ADA Curb Ramp New Construction Inspection Form (Perpendicular)

NW 292 st

23885.56

NW Keenon st

PERPENDICULAR RAMP (PR)

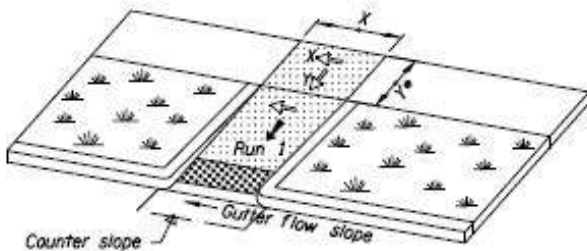
1RR ICRR IITD not full width
